Re: Permit No. M-1980-244; Cripple Creek & Victor Gold Mining Company; Cresson Project;
Technical Revision 144 – Adequacy Review Response

Newmont ECOSA Seepage Mitigation

EAST CRESSON OVERBURDEN STORAGE AREA (ECOSA) SEEP MANAGEMENT

SEEP COLLECTION FACILITY DESIGN

CS500

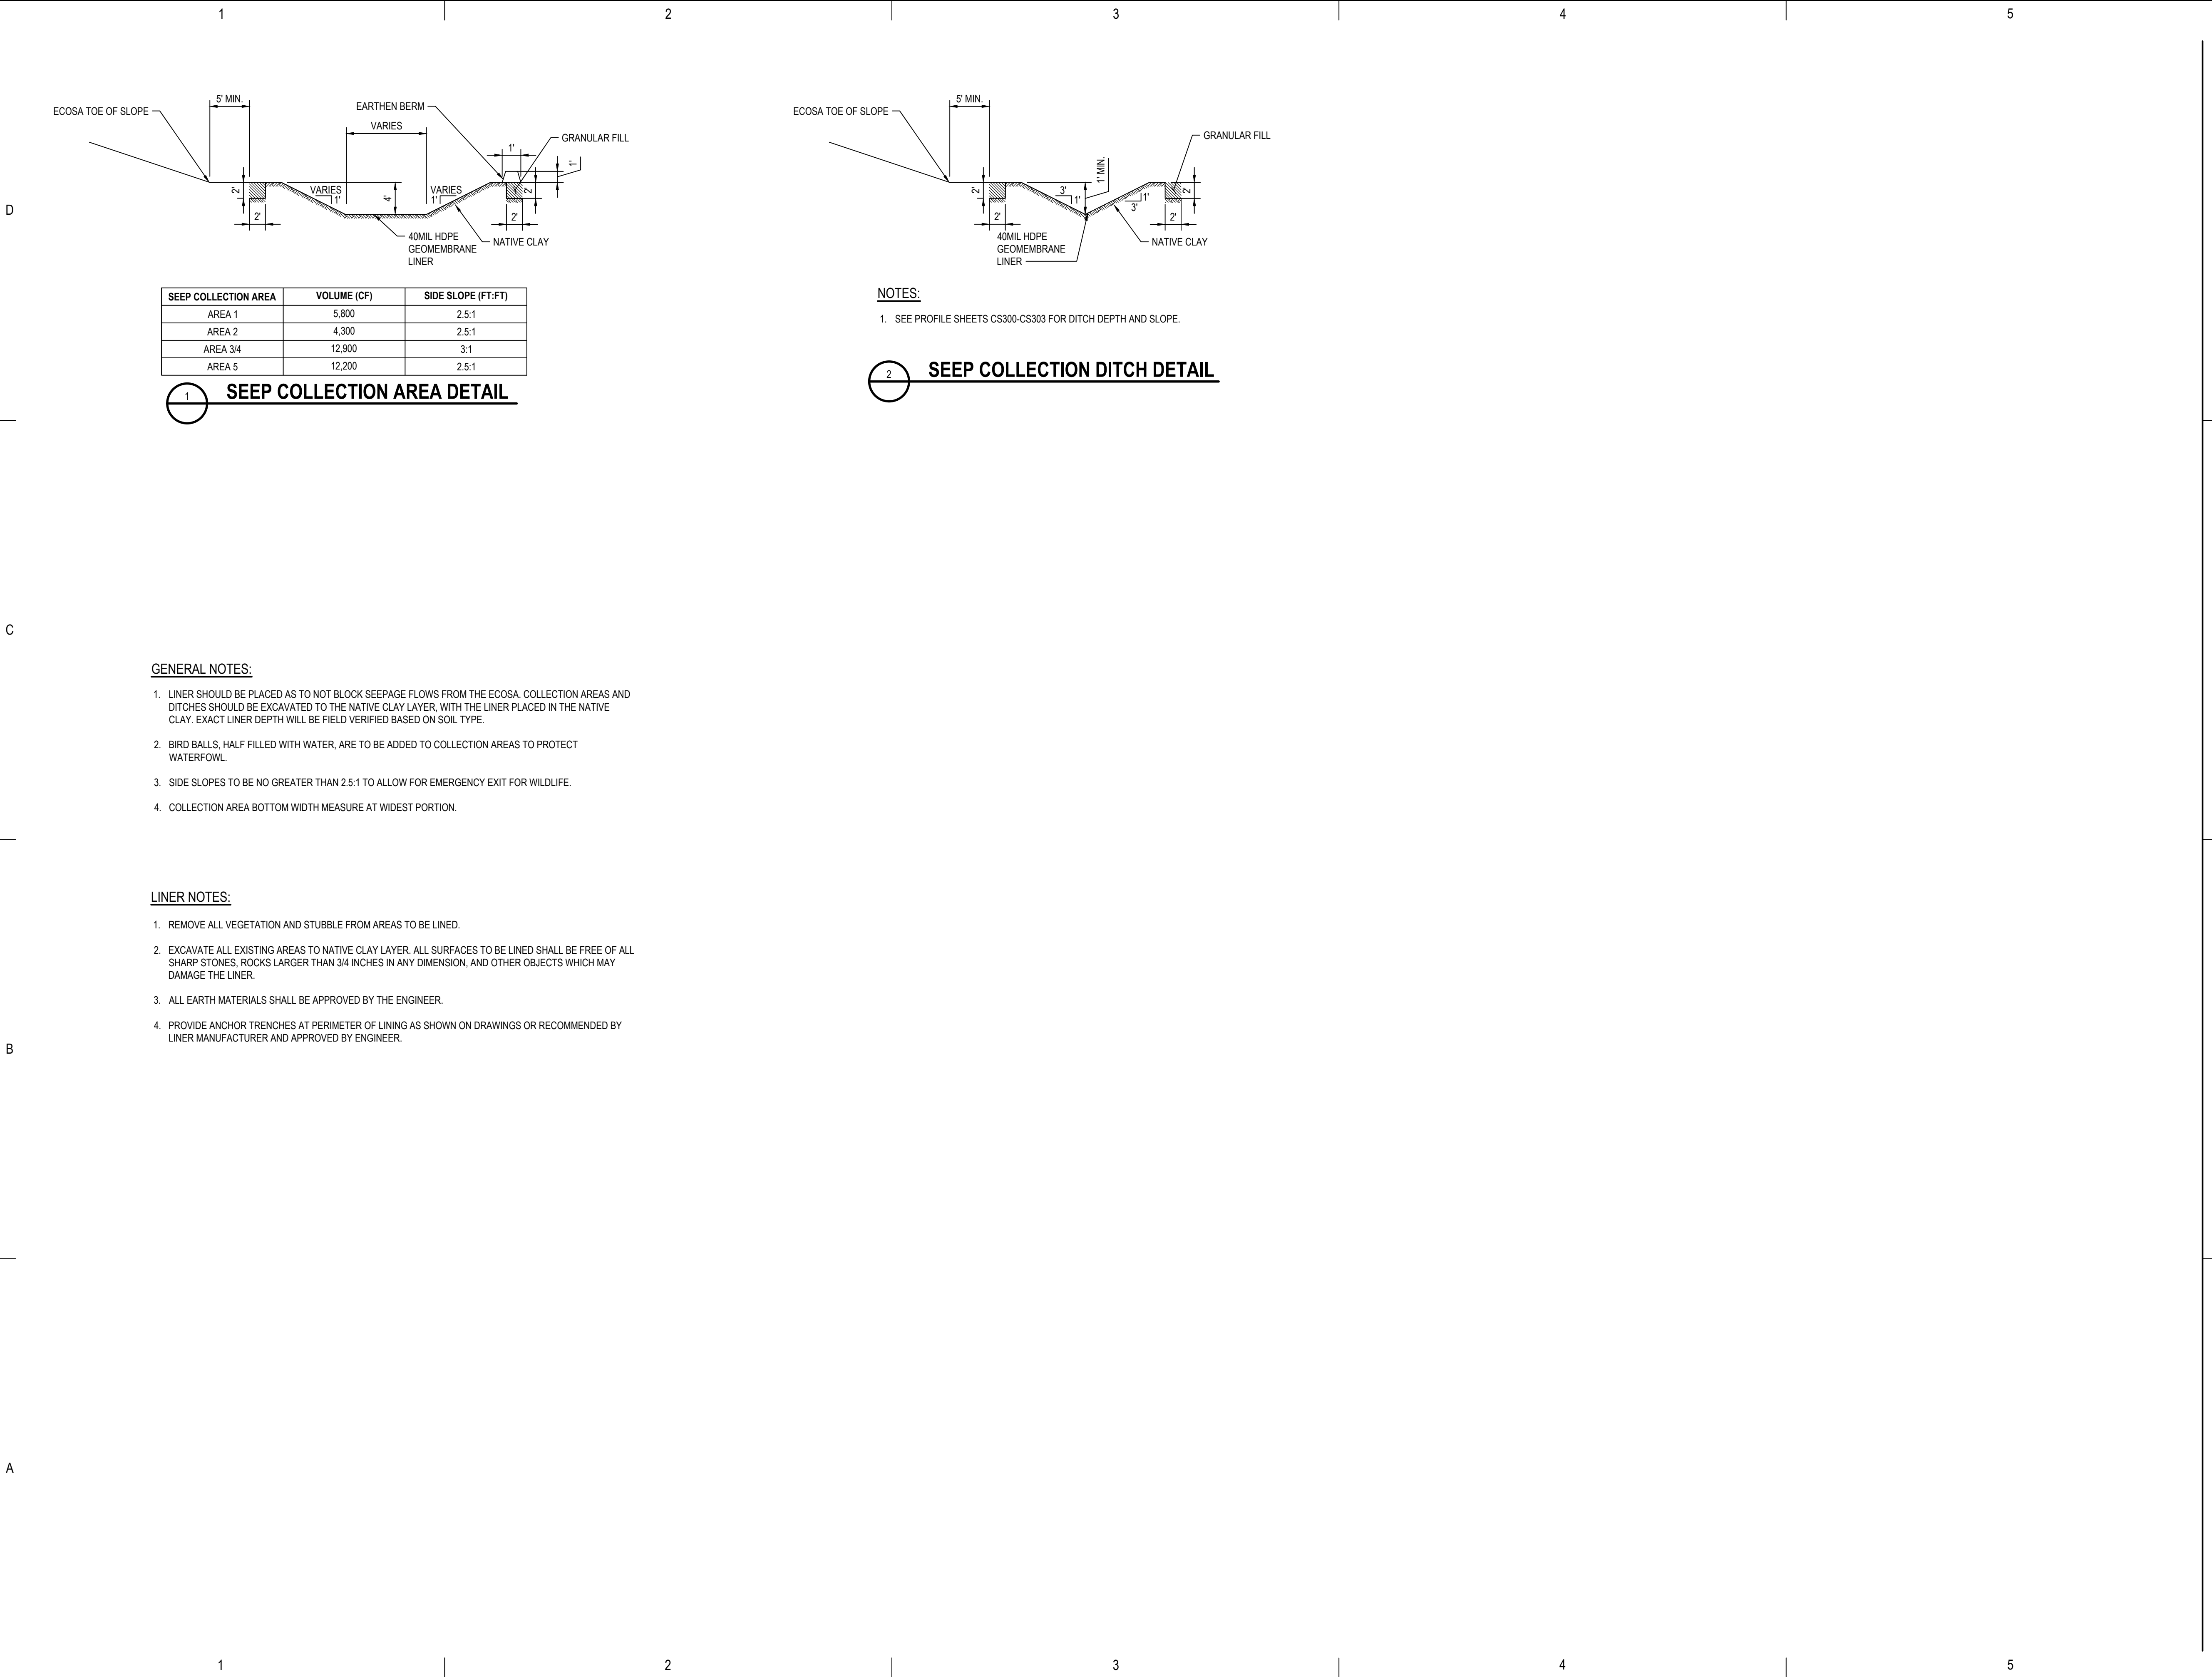
1. **In the last table, of section "Collection Area Sizing", the HDR memo gives the total volume of each collection basin. In the design drawing, CS500, the collection basin volumes are oversized. Please state how much freeboard the design drawing volumes allow for each basin. The Division will require a demonstration that there is a minimum of 2 feet of freeboard for each collection basin.**

The Collection Areas are designed to be pumped once per shift and contain seepage generated at the maximum historically-observed flow rate (during late summer monsoonal conditions) for 12-hours combined with a 2-year, 24-hour storm plus a 10-year, 24-hour storm. As currently sized, the 2-foot freeboard requirement is met for the 12-hour shift volume capacity.

High Water Level (HWL) lines have been added to the plans that indicate the water level. The plans also indicate the overtopping elevation of the collection areas. The collection areas have been designed based on the maximum anticipated volume for a 12-hour shift while maintaining 2-feet of freeboard.

Collection Area	HWL	Freeboard
1	9976.1	2.15
2	10012.6	2.4
3/4	9954.8	2.2
5	10032.3	2.7
